**Architectural Review Board Meeting Agenda**  
**Monday, February 9, 2026, 4:00PM Norfolk**  
**City Hall, 810 Union Street, 11<sup>th</sup> Floor**

## #26-00356 Certificate of Appropriateness Report

## #26-00358 Certificate of Appropriateness Report

## #26-00349 Determination of Architectural Appropriateness Report

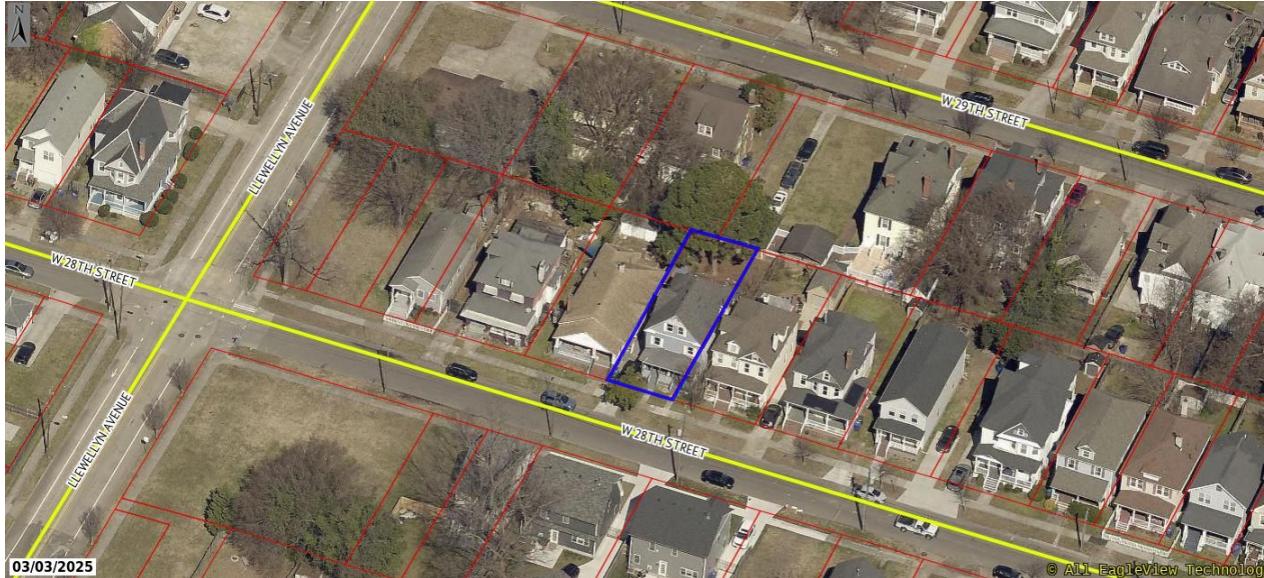
Staff notes that the proposal to use vinyl siding is inconsistent with the Secretary of the Interior's Standards for Rehabilitation, which recommend in-kind replacement of historic siding or restoration of the historic material when feasible. Photographs of the building's damaged exterior walls suggest that the existing vinyl siding was likely installed atop wood siding and, in at least one location, was installed over another layer of siding. The condition and extent of wood siding is yet to be determined, but it is relatively common to find that wood siding that has been covered with later synthetic materials has been well preserved. It is also common in Park Place to find vinyl siding on historic buildings, including ones that are identified as contributing resources. Given this, the retention of vinyl siding would not adversely affect the resource or the district. In Staff's opinion, the general integrity of the

In Staff's opinion, as the building's status as a contributing structure in the Park Place Historic District is what qualifies the continuation of the nonconforming use and as the applicant will be retaining a non-historic cladding and will be further modifying fenestration, improvement of the front porch to remove non-historic elements and replace them with appropriately proportioned features (columns and railings) is warranted. Most of the front porch appears to have been reconstructed at some point in the past. The existing front railings—which are approximately 42 to 45-inches tall—are too tall and have too narrow and closely spaced balusters. The posts are similarly insubstantial as 6"x6" posts. A 36-inch tall railing with 2"x2" balusters with at least 4-inch spacing and 10"x10" posts with a cap would be more appropriate for the house. This mitigation would, in Staff's opinion, offset some of the other proposed modifications of the building and better relate the building with the rest of the 200 block of W 28<sup>th</sup> Street. Staff does note, however, that the current front porch configuration has existed since at least 2007 according to available street images from Google Streetview.

1. Annotated elevation drawings shall be provided to City Staff identifying the extent of fire damage to the exterior wall, siding, and roof.
2. The plans shall be revised to retain any historic wood siding on the building and to install new vinyl siding over any historic siding in a way that can be reversed in the future.
3. The front porch shall be modified to have more historical proportions, including lowering the current railing height to no more than 36 inches, replacing the existing balusters, and replacing the 6"x6" posts with 10"x10" posts, subject to ARB Staff review and approval.
4. Repairs to the roof shall be in-kind with similarly colored dark gray asphalt, composite, 3-tab or dimensional shingles.
5. Any changes to the scope of work affecting the exterior of the building shall be returned for review and approval to the Architectural Review Board.
